Brief by Gilles Primeau, M.Eng., Pilot (private)

To the Standing Committee on Transport, Infrastructure and Communities (TRAN)

Regarding the subject being studied of the Aircraft Certification Process

Upset Sensor with Maneuver MVS Algorithm Behavior

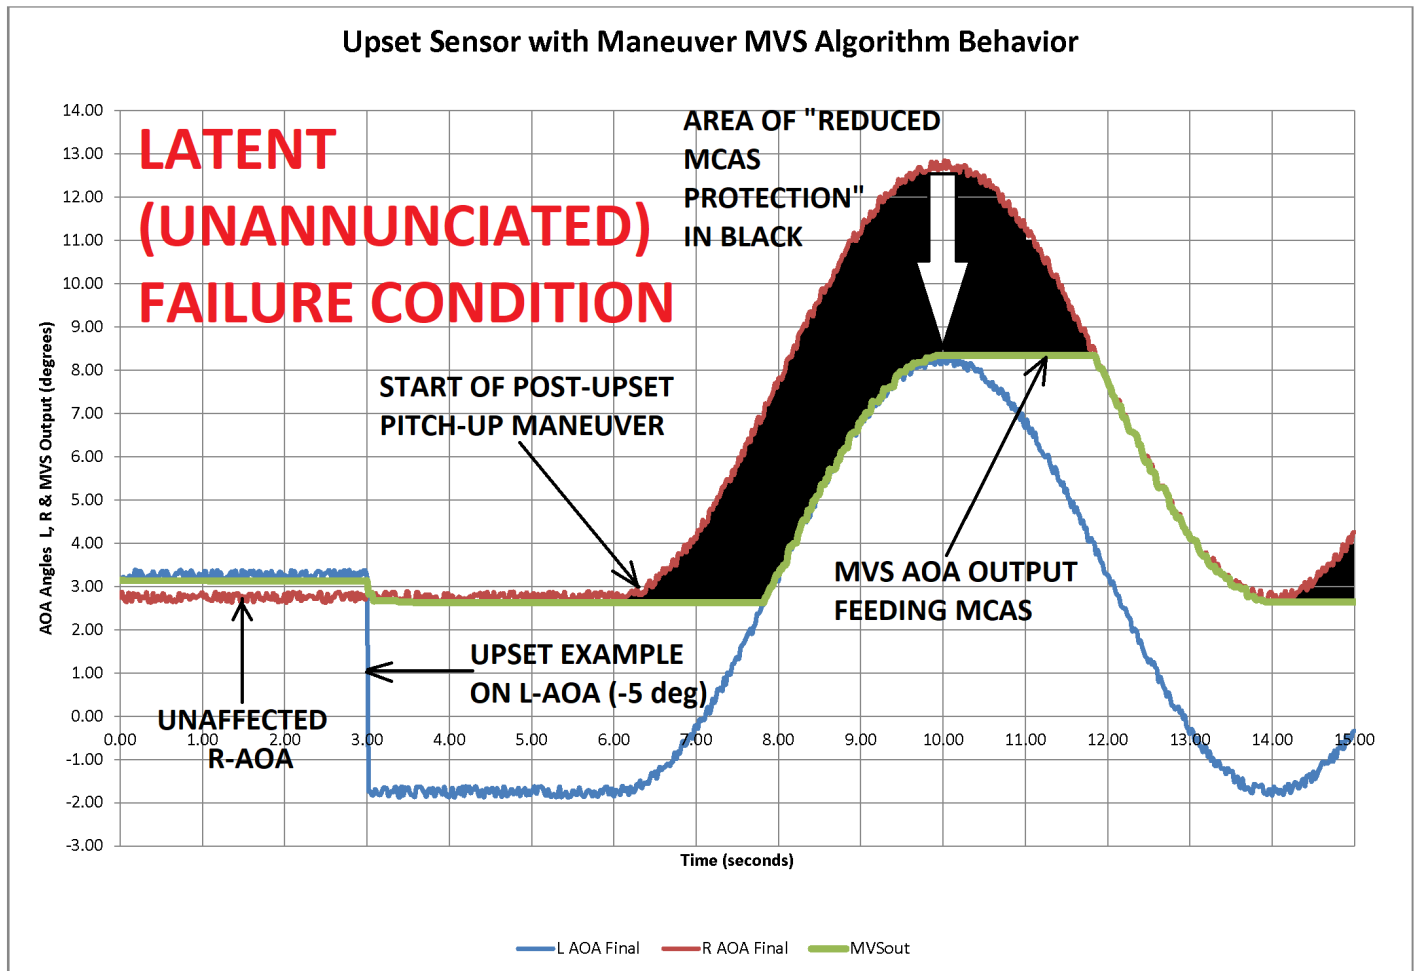
FAA NPRM documentation^(1, Att.3) described the *mid-value select* (MVS) algorithm which operates using 3 parameters: left AOA, right AOA, and MVS output, latter being the middle numerical value from those 3 choices, iteratively-computed. Very importantly, the MVS algorithm does not trigger a fault if the difference between the L&R AOA signals is less than 5.5°. The author developed a simulation of the MVS algorithm, with several adjustable parameters including independent random noise on each AOA source for representativeness. The scenario illustrated in the next figure highlights a potentially hazardous situation when a specific type of AOA upset is combined with a required crew maneuver:

Initially, both AOAs track each other normally and the MVS algorithm selects either the L or R AOA signal, both adequate. Postulate firstly that suddenly, as happened on ET302, one AOA suffers an upset (L-AOA in blue), but toward LOWER values, and by less than the MVS algorithm's 5.5° differential fault threshold. Due to the MVS algorithm logic, its output (green trace) will correctly switch to the unaffected other sensor (R-AOA in red). Postulate also secondly that the crew later has to make a sudden high amplitude pitch up maneuver (typically for collision avoidance); the MVS output will remain constant despite both AOAs rising, until the affected L-AOA reaches the same MVS output value, at which point the MVS output will switch to the signal from the affected L-AOA, thus becoming biased down by the magnitude of the L-AOA upset, thereby feeding the MCAS with a lowered activation threshold, delayed by a potentially critical amount of time to prevent an aerodynamic stall in this dynamic example. It's extremely important to consider the latent (or dormant, i.e. unannounced) nature of this failure condition, because the crew would be misled into believing the MCAS would intervene to avoid a stall if their collision avoidance maneuver was too aggressive (which tends to be the case for urgent maneuvers), since no MCAS fault would be posted to the crew to warn it to be careful. The upset could happen long before the flight, for instance due to the sensor being hit during ramp operations, and remain latent/dormant. Even simulator training can be misleading, unless this specific type of dormant upset could be injected by the simulation instructor, unnoticed by the crew, followed by creating obstacle avoidance conditions. This latent failure condition is real and undeniable. The dependable relief from it should in principle have to take into account statistical considerations of exposure time to the AOA sensor upset/failure probability, combined with the probability of the need for an aggressive collision avoidance maneuver. TCCA told the author that the MVS was reviewed by TCCA Engineering and critical cases evaluated by TCCA Flight Test in Boeing's Engineering Simulator, that these reviews and evaluations included Loss of MCAS with consideration for the MSV contribution, which led to the conclusion that the design was deemed acceptable. This conclusion, in the author's opinion, implies that the engineering analysis/evaluation and simulator
